Art Unit 3749

4. Drawings

FIG. 1

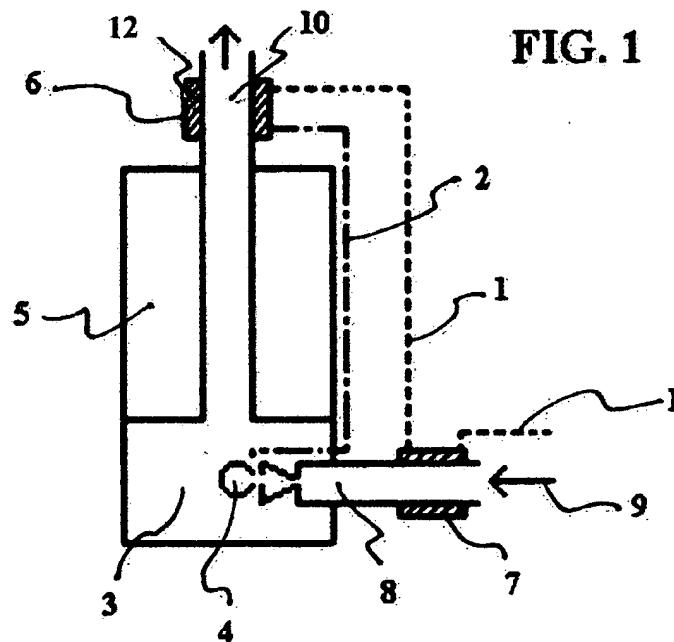
The drawings are objected to under 37 CFR 1.83(a). The drawings must show every feature of the invention specified in the claims. Therefore, the insulating material forming part of the heat exchanger assembly and the heat storage material being formed as part of the heat exchanger assemblies (claims 28 and 40) and the heat transfer zones being operated form a source other than the combustion or exhaust vent area of the combustion mechanism (claims 31 and 43) must be shown or the feature(s) cancelled from the claim(s). No new matter should be entered.

The Examiner states that the insulating material cited in Claims 28 and 40 is not being shown, when indeed such insulating material, or heat storage material, is indicated in the drawings as the hatch drawn feature surrounding the heat exchanger assembly 6, located at exhaust area 10, as well as the hatch drawn feature surrounding heat exchanger 7 which, as very obvious in the drawing, is located at a heat transfer zone being operated by a source other than the combustion or exhaust

In addition, Applicant is illustrating in Fig. 1 of the drawings, how and where the cool fuel 1 passes through the zone at heat exchanger assembly 7, before being routed through fuel heating exchange assembly 6, in order to first cool combustion air 9 prior to its delivery to the combustion zone 3. The Examiner should refer to page 8 of the description, under "Detailed Description of a Preferred Embodiment", where under Figure 1, the various relative steps of the invention are fully explained and detailed. Furthermore, on page 2 last paragraph, Applicant specifies the need to provide the lowest possible combustion air temperature in order to obtain the most advantageous operating condition.

In addition, Applicant is illustrating in Fig. 1 of the drawings, how and where the heat transfer zone in question is located at the combustion mechanism's combustion product exhaust area 10, which, as is well known to someone familiar with the art, is always related to the energy transfer zone 5 of a combustion mechanism. The Examiner should again refer to page 8 of the description, under "Detailed Description of a Preferred Embodiment", where under Figure 1, the various relative steps of the invention and the locations of the heating zones relative to the exhaust area of the combustion mechanism are fully explained and detailed.

The Examiner is therefore mistaken when objecting to the drawings, because the drawings already conform with 37 CFR 1.83(a). The drawings in fact precisely show the required features of the inventions as referred to in the objected Claims, and no alteration, amendment or addition to the drawings should be required.

FIG. 2

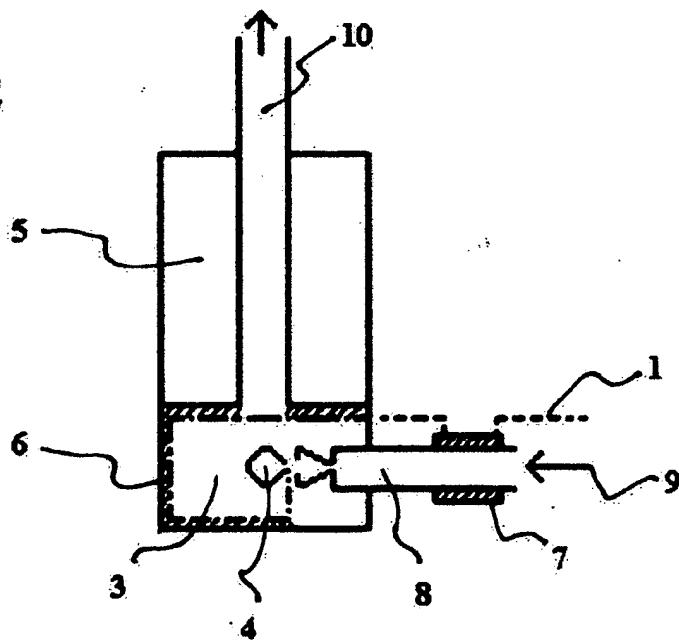
Applicant is illustrating in Fig. 2 of the drawings, that the heat transfer zone in question is located near the combustion mechanism's interior combustion area 3 and is identified as area 6, which, as is well known to someone familiar with the art, is the first energy transfer zone of a combustion mechanism, experiencing further high temperatures. The Examiner should again refer to page 8 of the description, under "Detailed Description of a Preferred Embodiment", where under Figure 2, the various relative steps of the invention and the location of the heating zone relative to the combustion area of the combustion mechanism a is fully explained and detailed.
